SUBJECT PROJECT CONCEPT REPORT APPROVAL

SUBJECT PROJECT CONCEPT REPORT - Red Oak Drive Bridge and Extension

**IR-75-2(171), Bibb County  
Red Oak Drive Extension**

PROJECT NAME: RED OAK DRIVE BRIDGE AND EXTENSION

# BIBB COUNTY

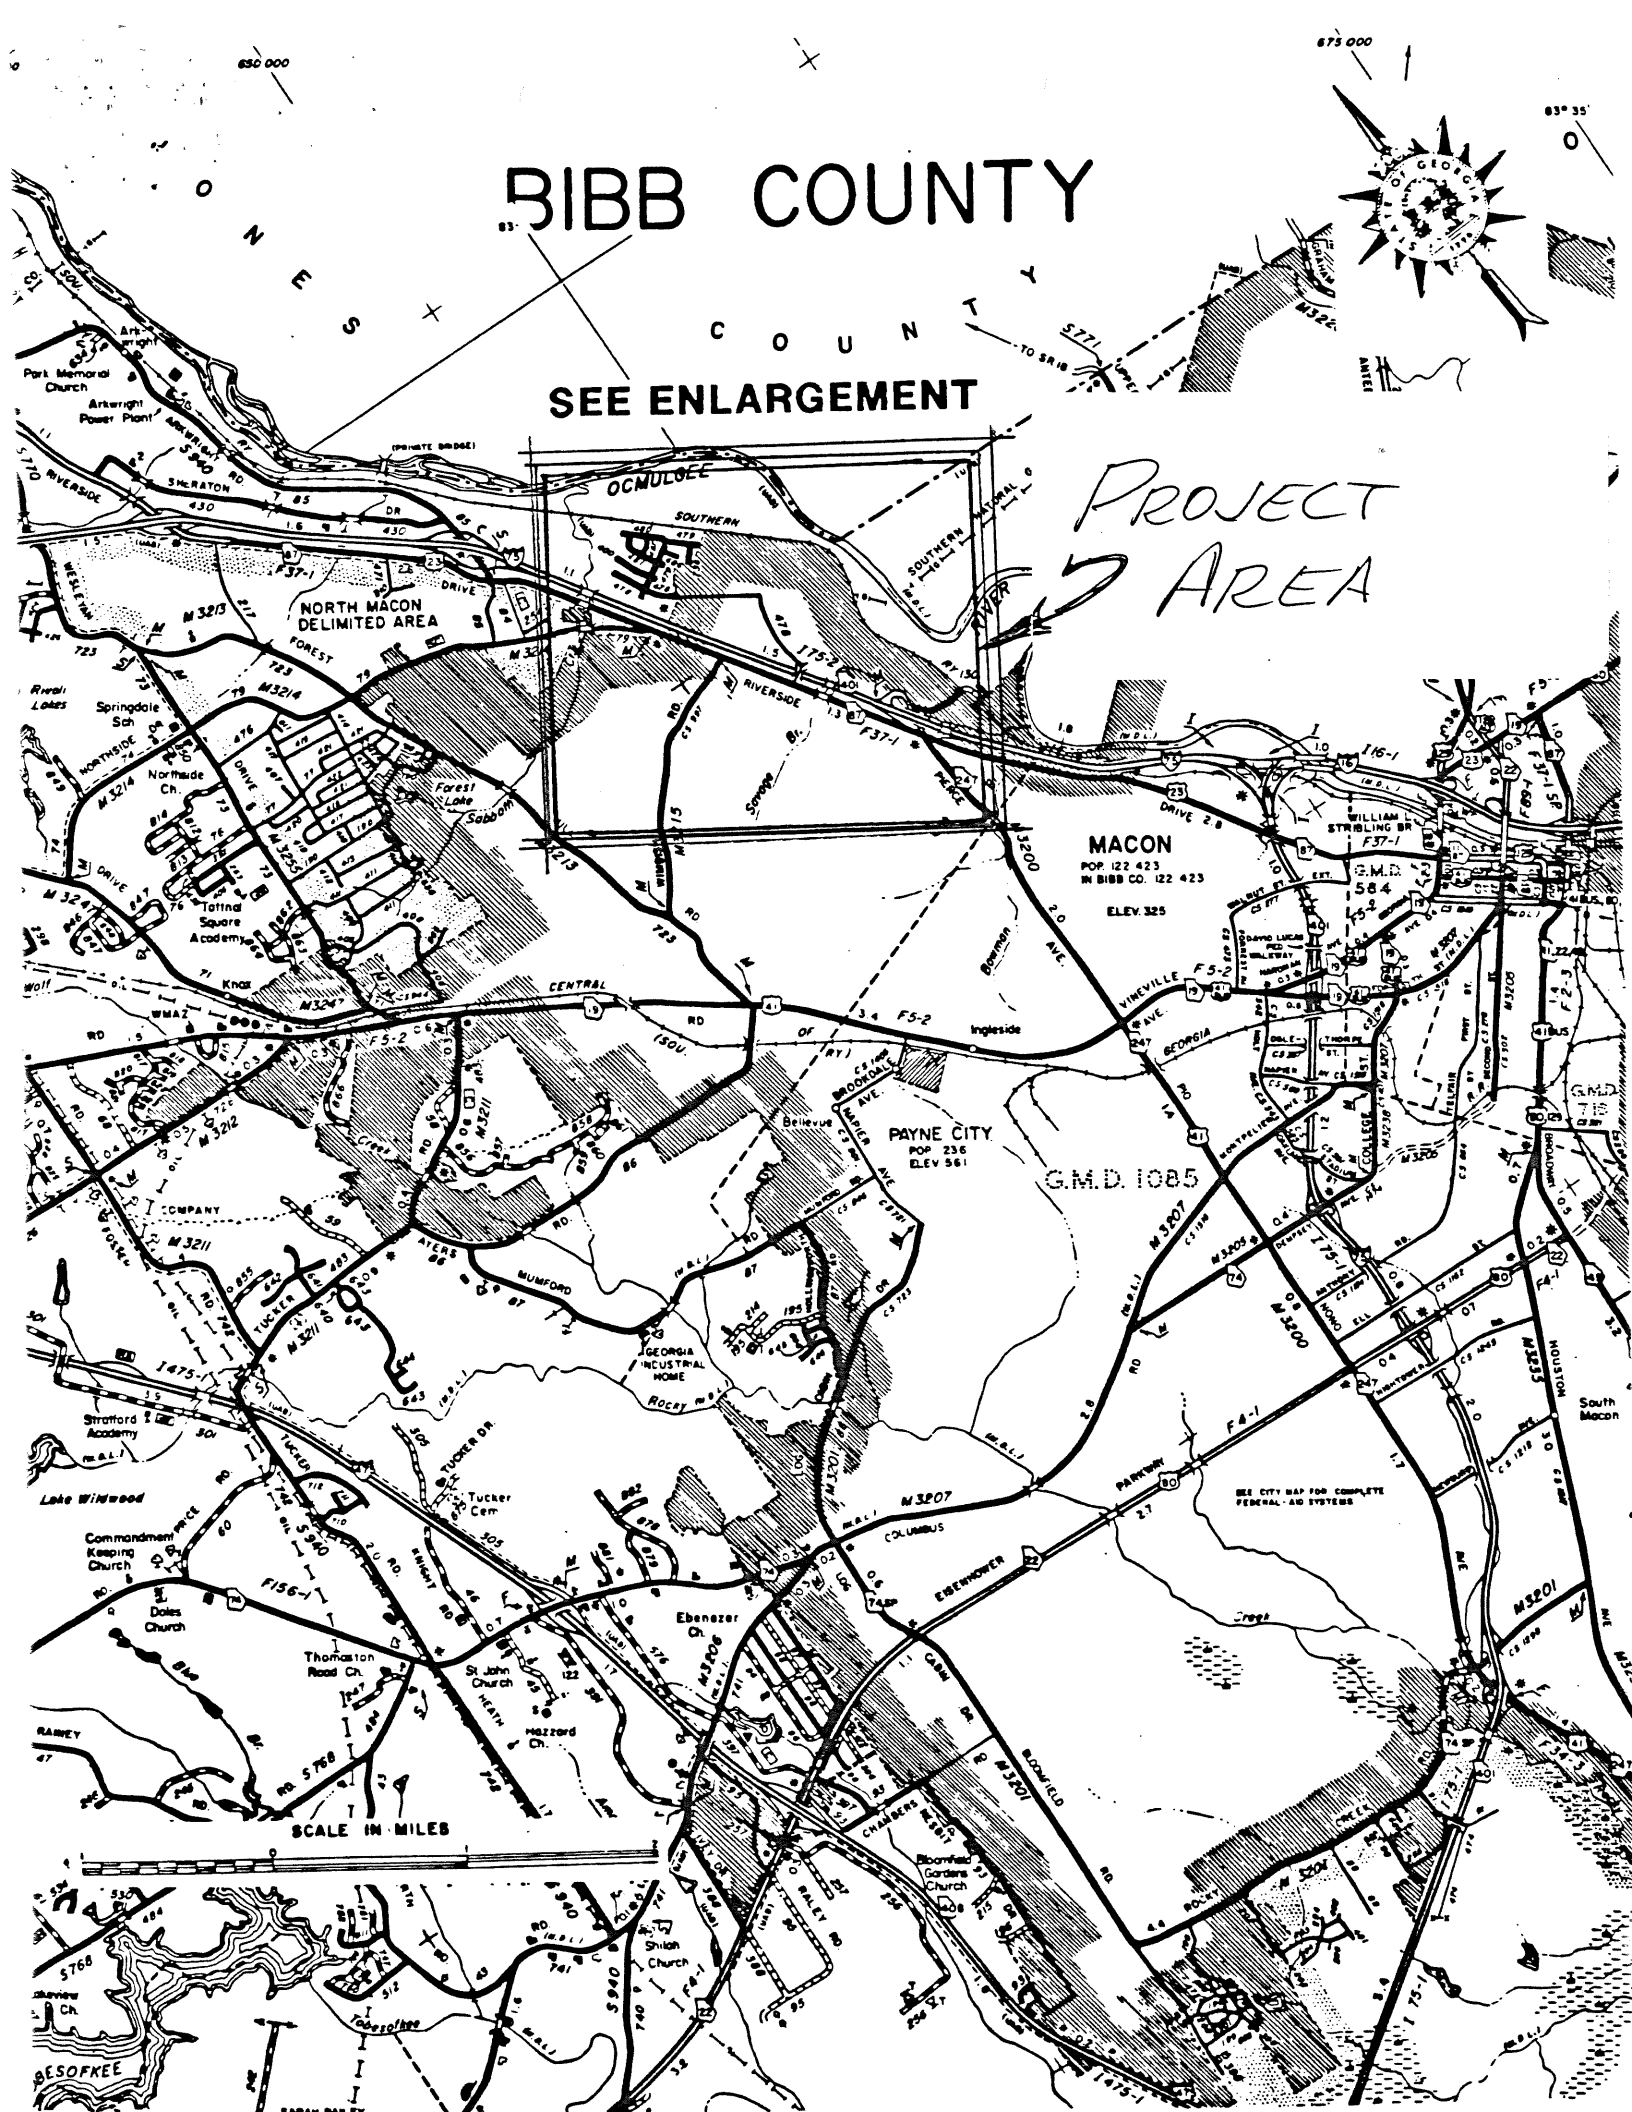
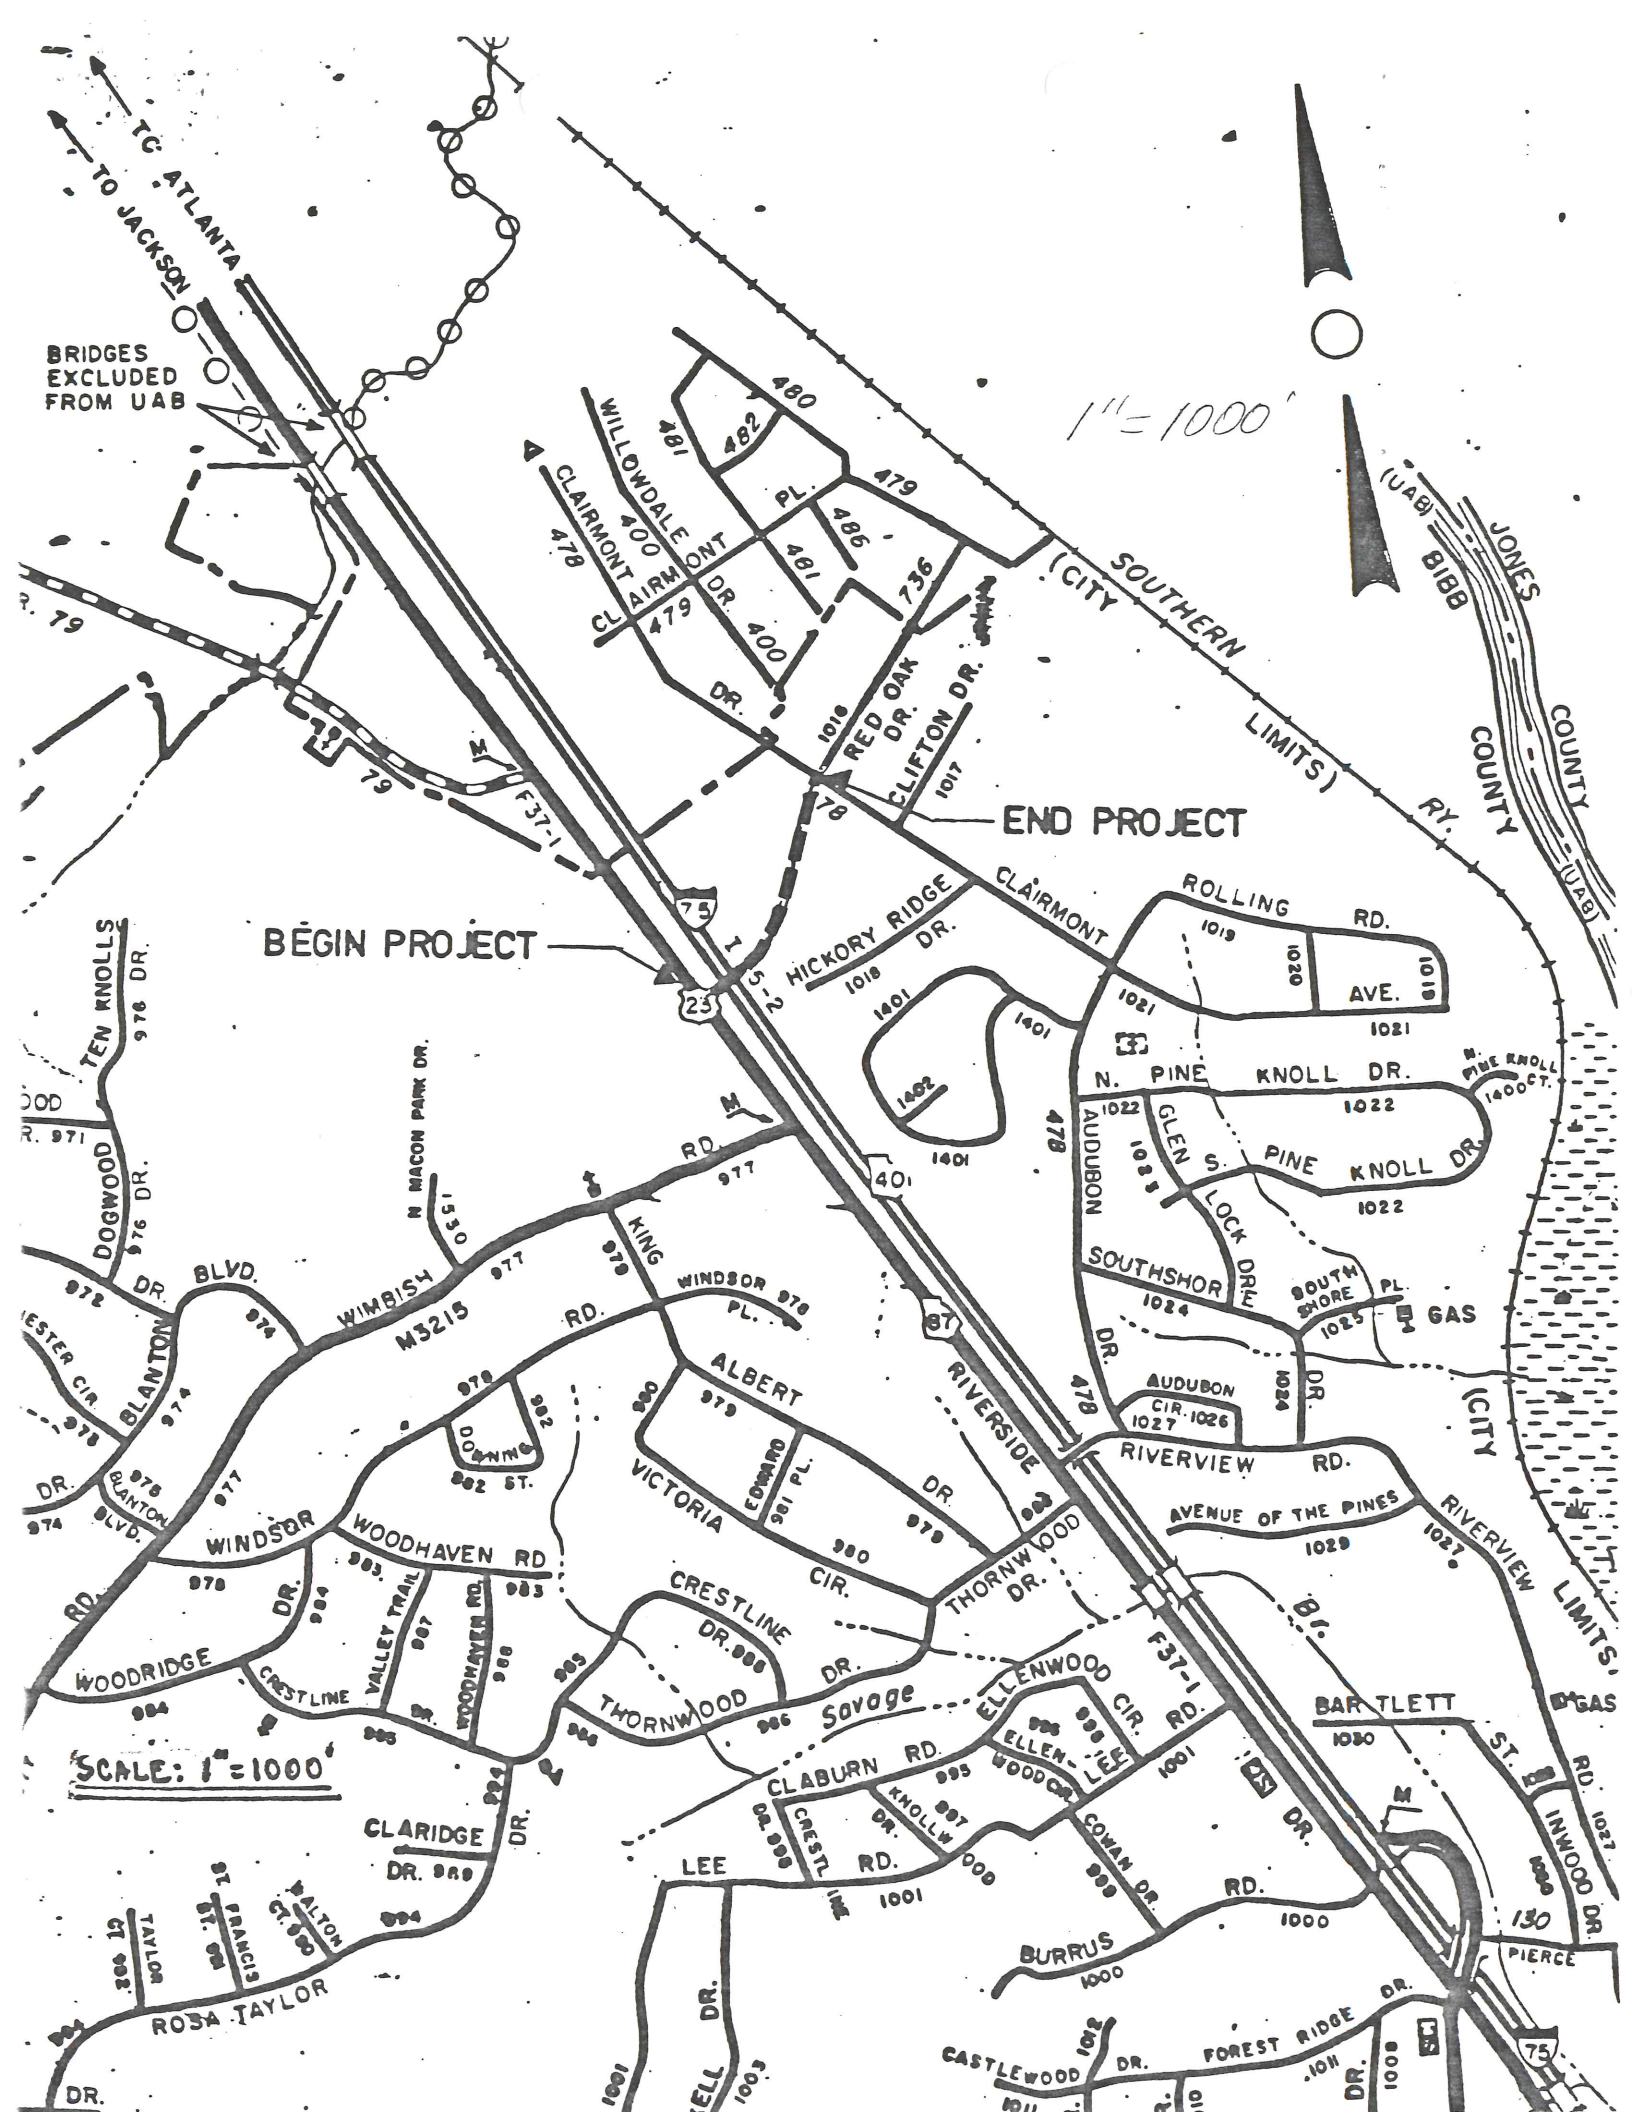
1. It is recognized that the location of the crossing is dictated to a large extent by the vertical profile of I75 and Riverside Drive. However, introduction of this new intersection at the location indicated on the sketch map is going to result in problems with left turn movements and at some point in time probably a new traffic signal. This will result in slowing the traffic through the area. The local government needs to consider realigning Wimbish Road to match the new proposed crossing.

TYPICAL BRIDGE SECTION

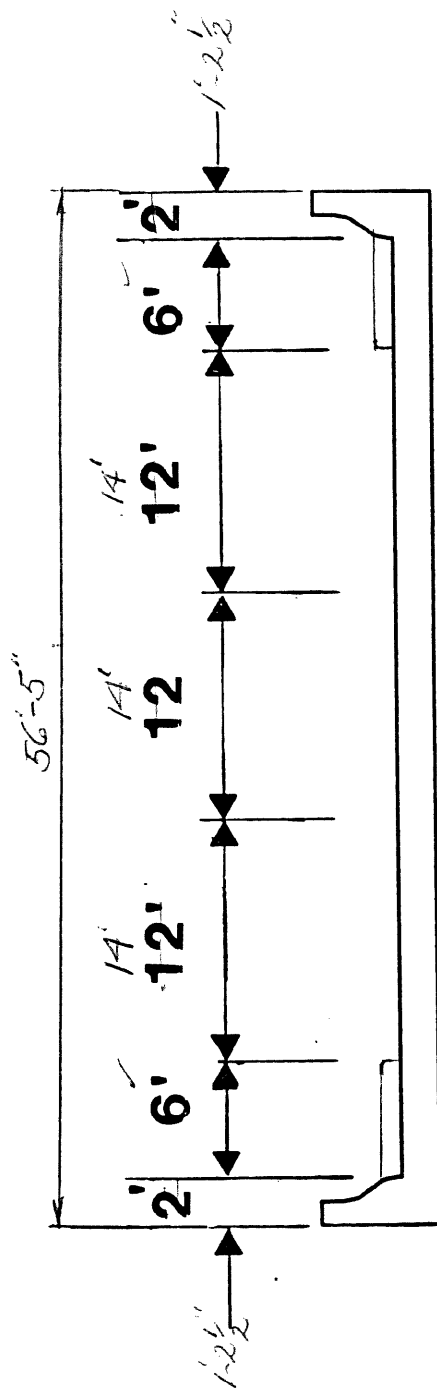
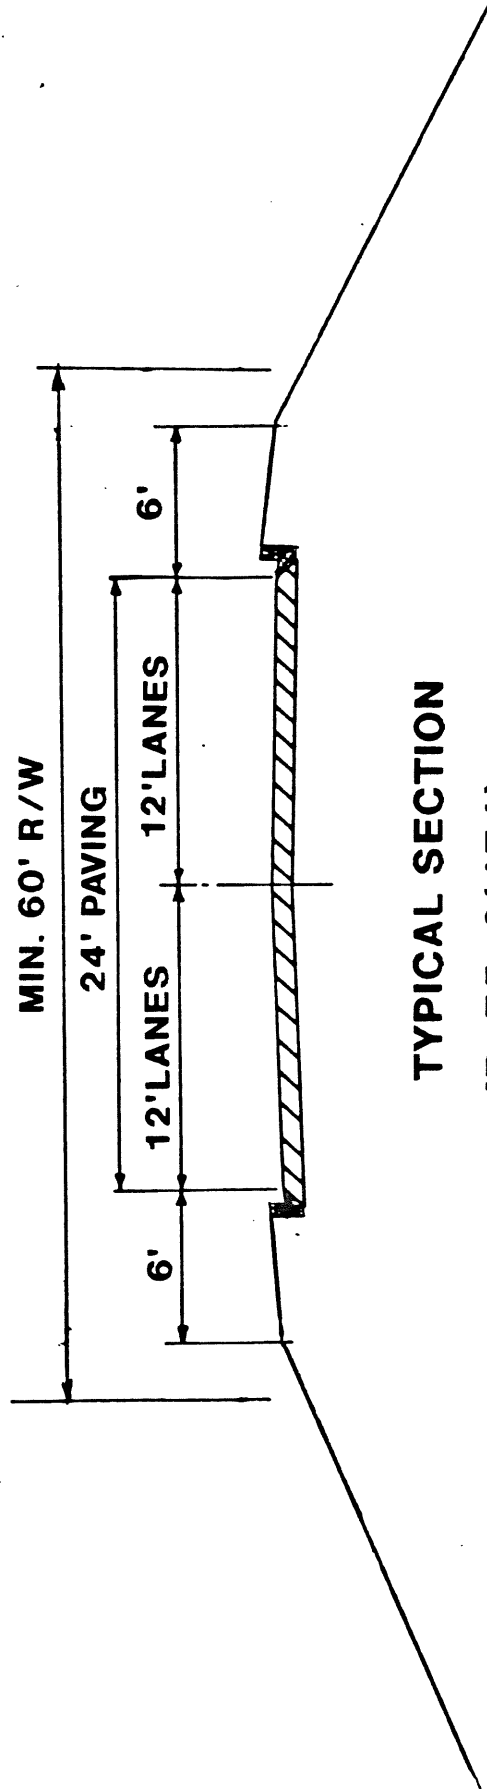
2. The typical section for the roadway indicates a curb and gutter section. The bridge typical section does not indicate curb and gutter. If the roadway section is correct, curb and gutter and a sidewalk will be used for the bridge. This will result in a slightly wider bridge than indicated in the cost estimate.

*3 lanes @ 12' + 2-10' shoulders = 56' <sup>ML</sup> 6/4/90*

2-LANE URBAN COLLECTOR WITH 6' GRADED SHOULDERS ON A MINIMUM 60 FEET OF RIGHT OF WAY. THE  
BRIDGE IS PROPOSED TO BE WIDE ENOUGH FOR 3 LANES OR <sup>56'-42</sup> 52 FEET WIDE.
